2000-1 Addison Circle

Roundabout Design & Operational Review (Lee  
Engineering) - 2005

**ADDISON CIRCLE  
DESIGN, OPERATIONS, AND SAFETY REVIEW**

July 2003

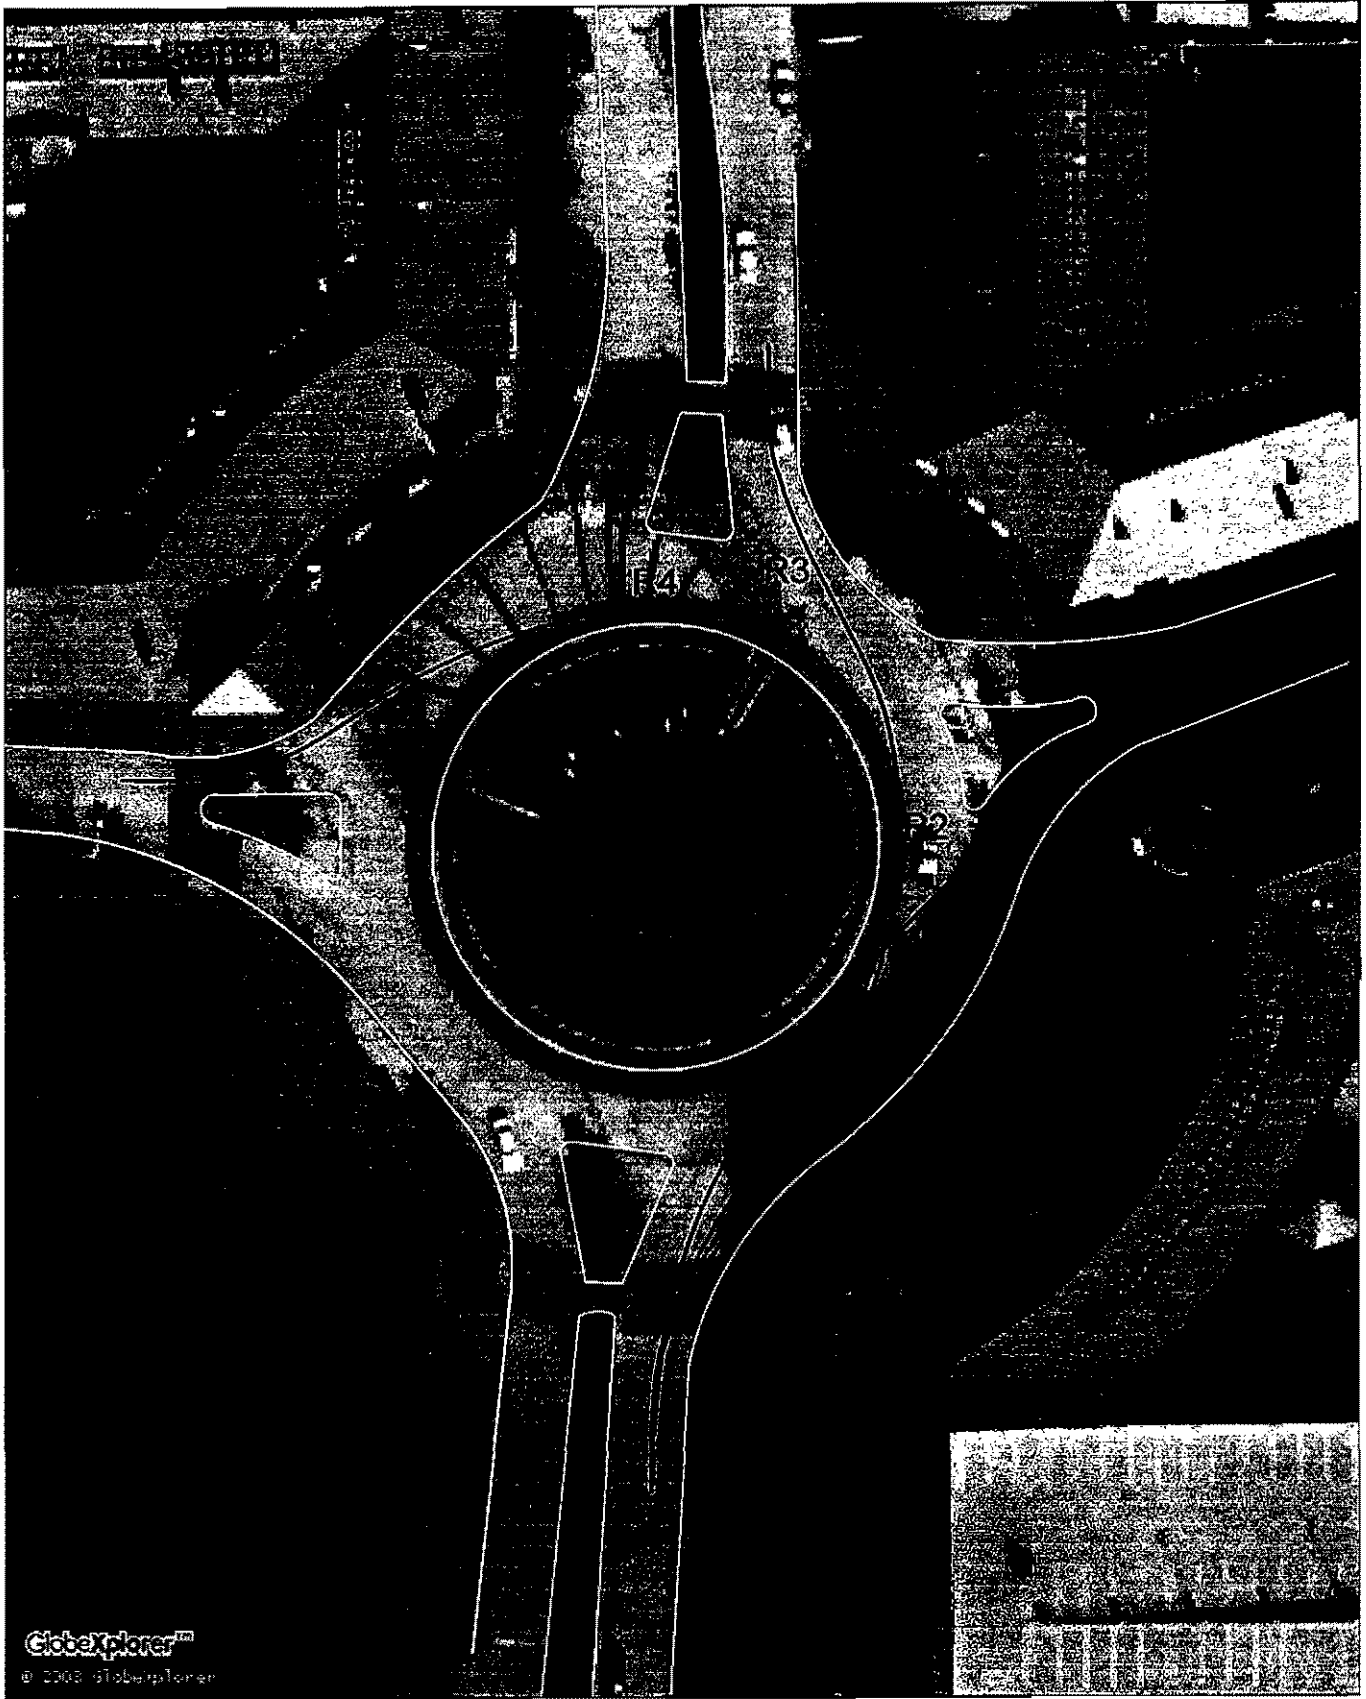
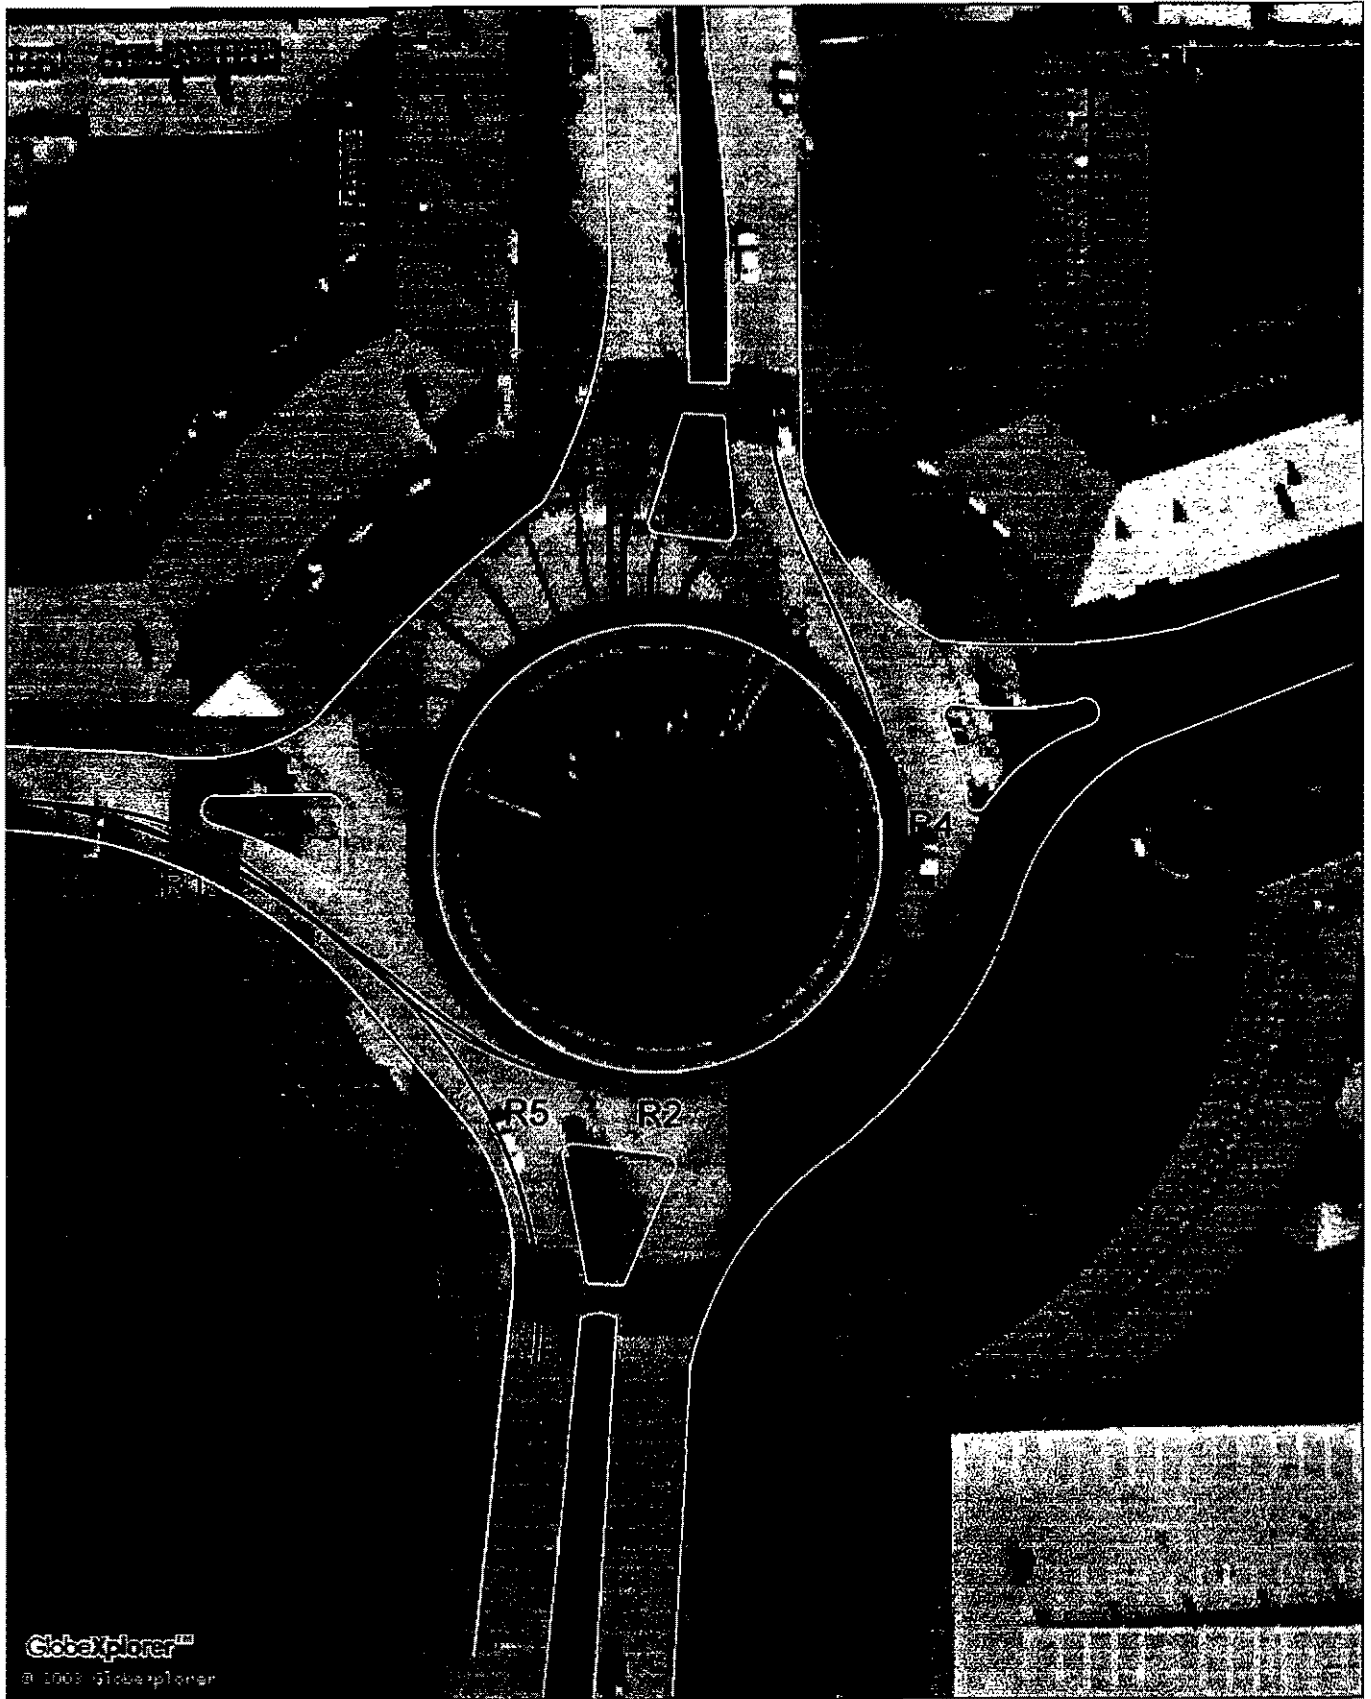
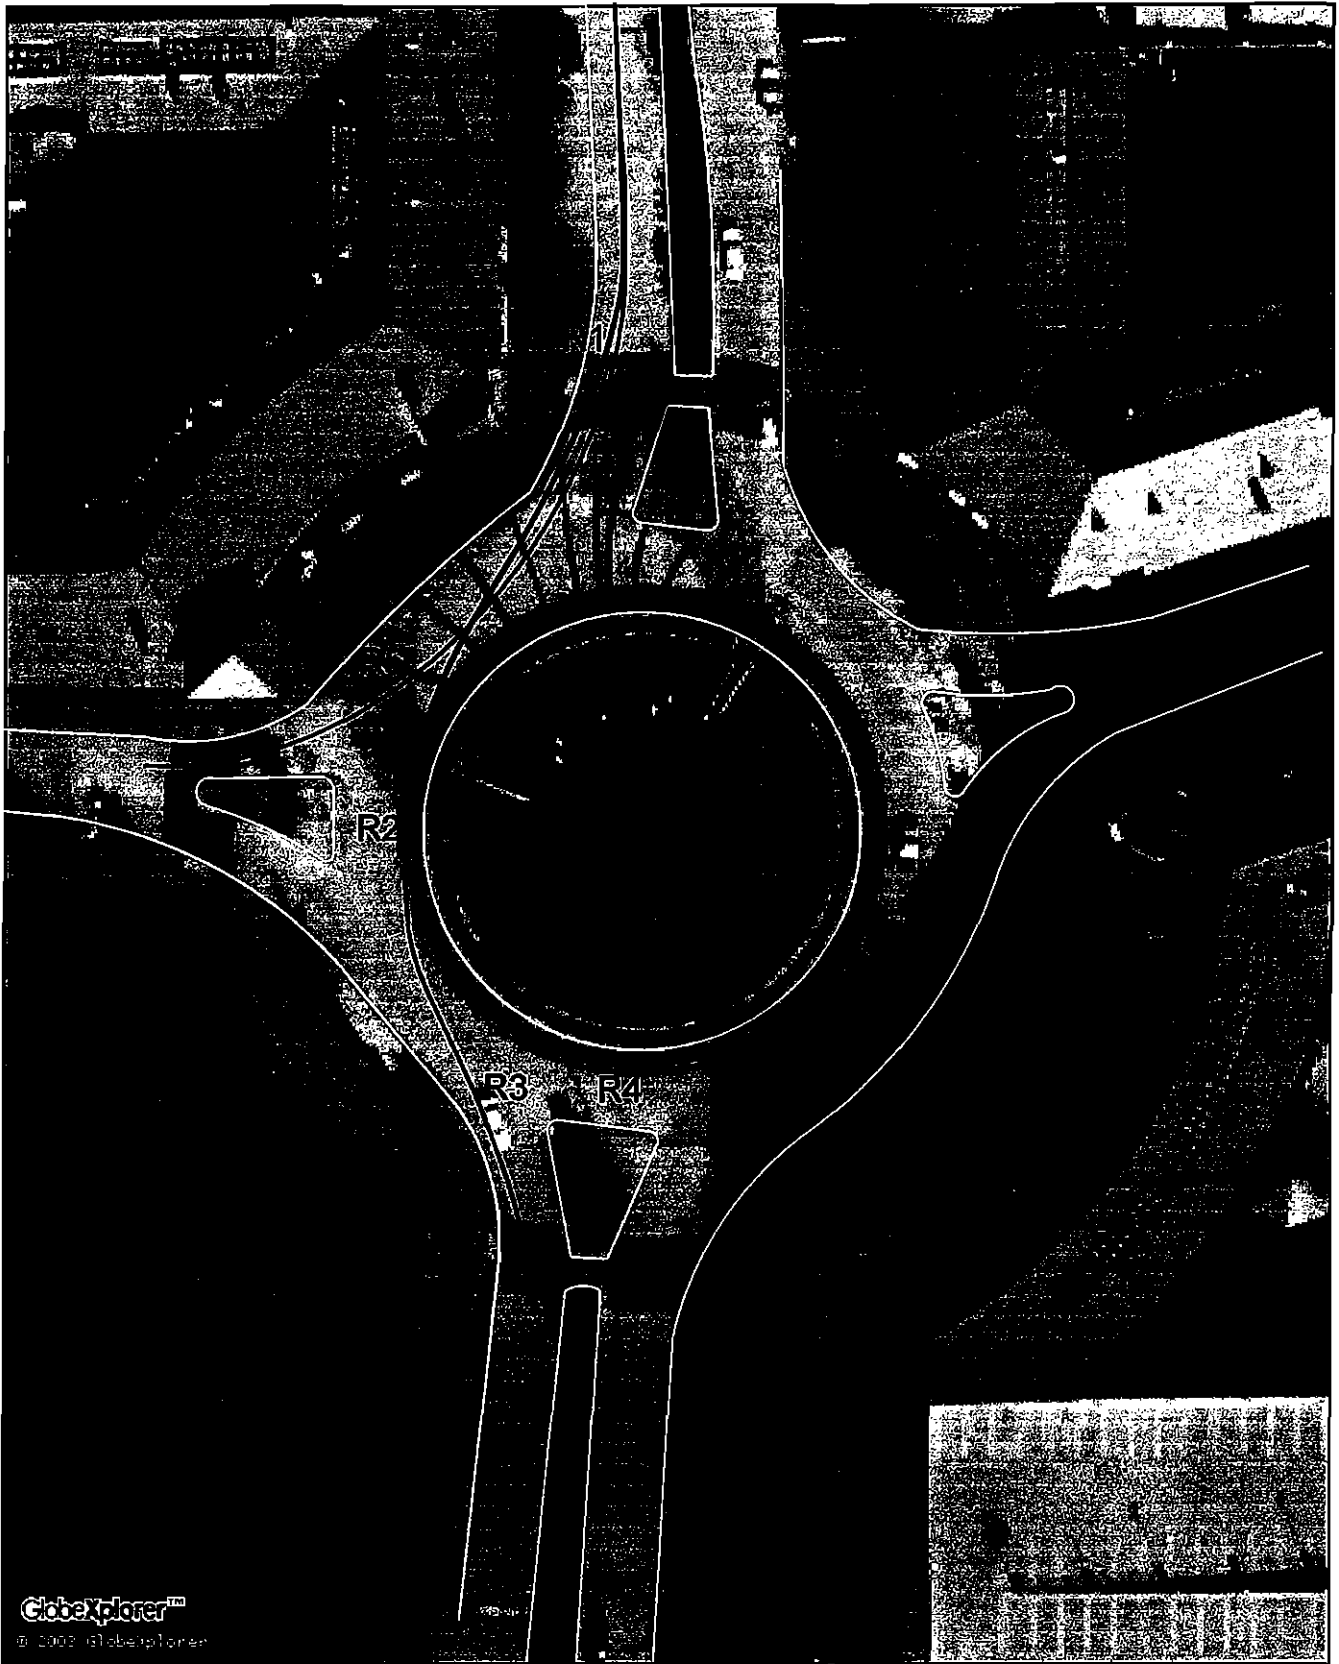
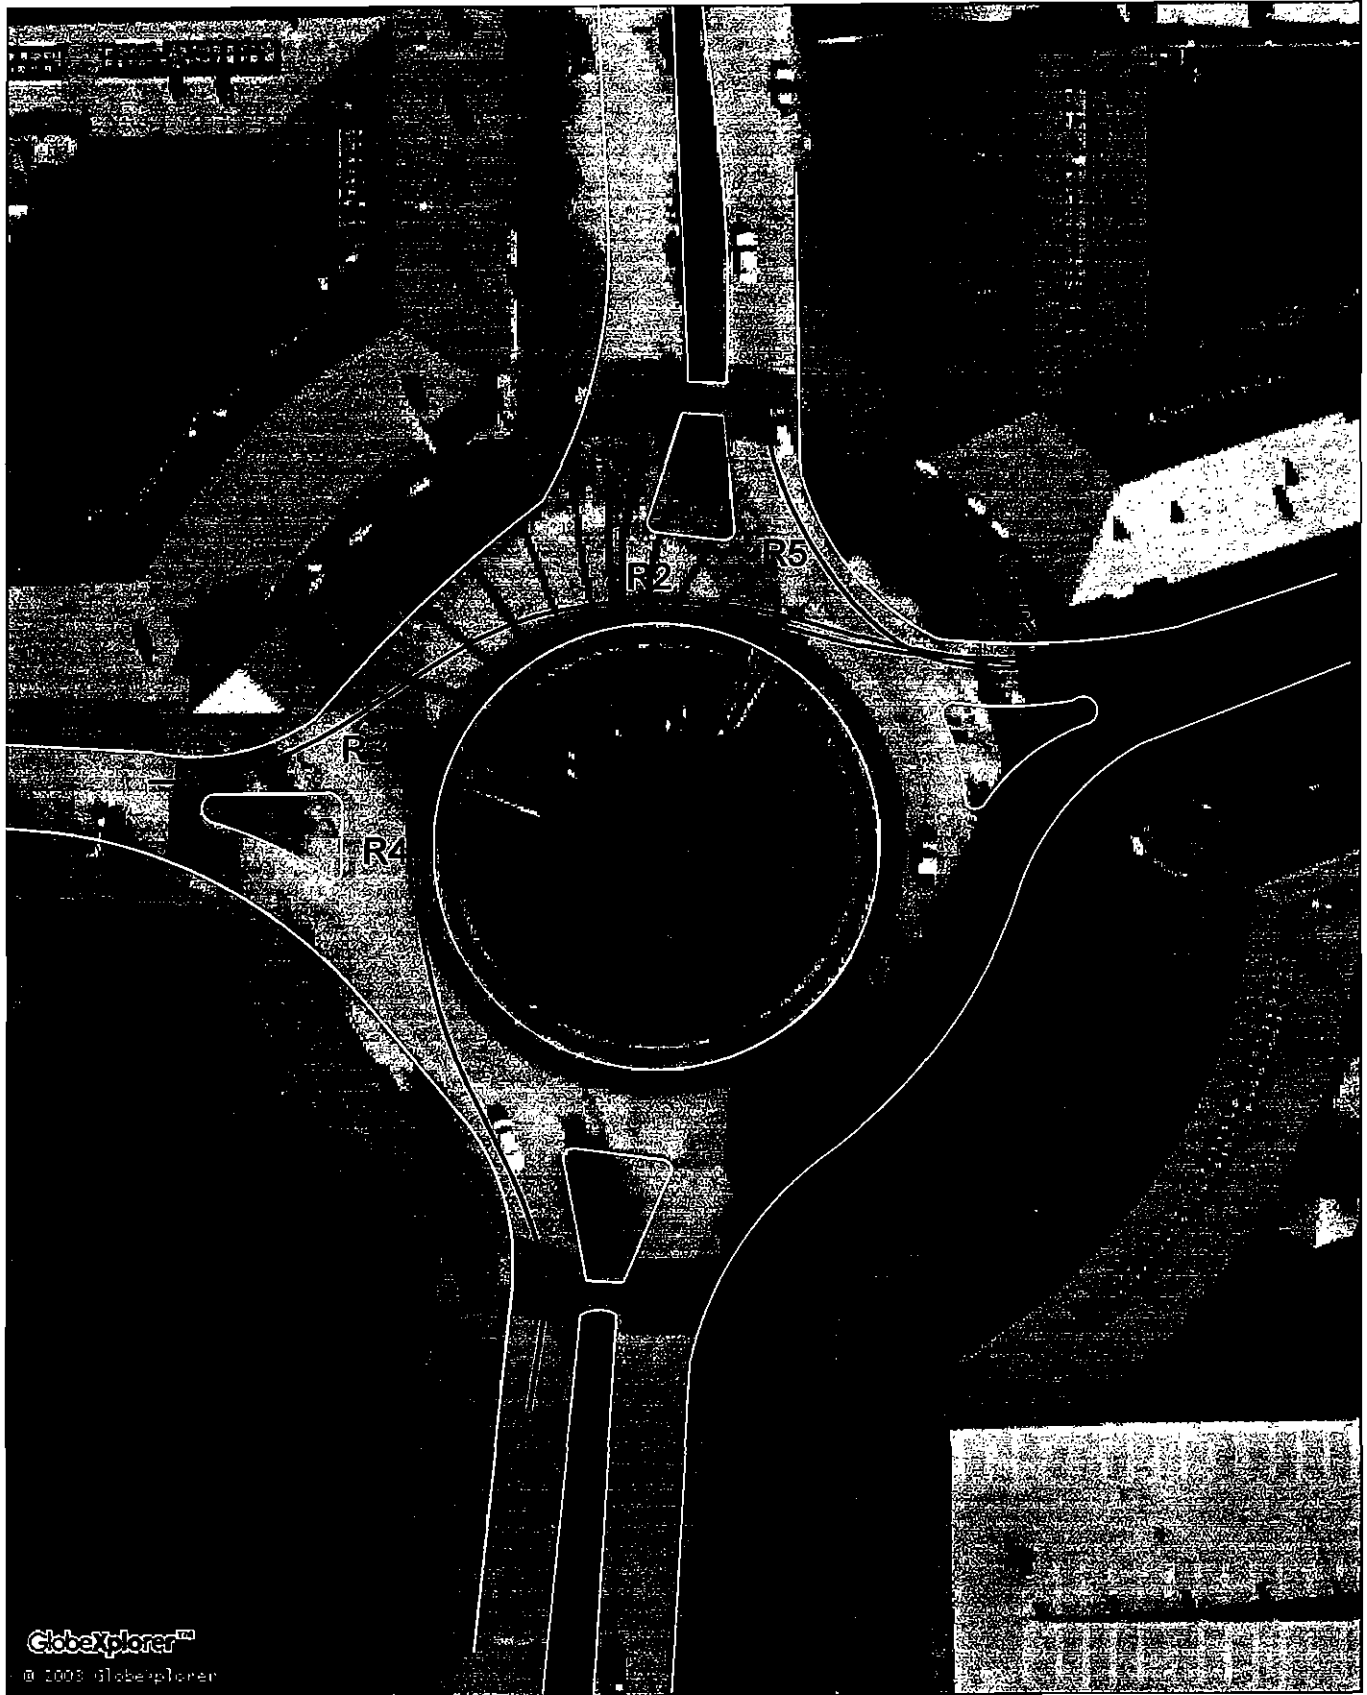
At the Addison Circle roundabout, only the southbound and westbound approaches have design speeds greater than or equal to the target design speed of 25 mph. The circulating design speed (R4) is 16 mph. The westbound right-turn design speed (R5) of 14 mph is the lowest speed within the roundabout. Overall, the consistency between consecutive or conflicting curve radii is good for the Addison Circle roundabout. The majority of consecutive curves fall within the six mph desired maximum differential. The highest speed is the northbound right-turn movement (R5). The 26 mph speed present on the northbound right-turn is also the only speed 12 mph or more above another speed on the roundabout. Minimal impact on safety results from this speed differential though as the paths for these movements do not conflict. The greatest speed differential for crossing/overlapping paths is the eight mph difference between the westbound R5 and northbound R3. This is less than the 12 mph differential identified above.
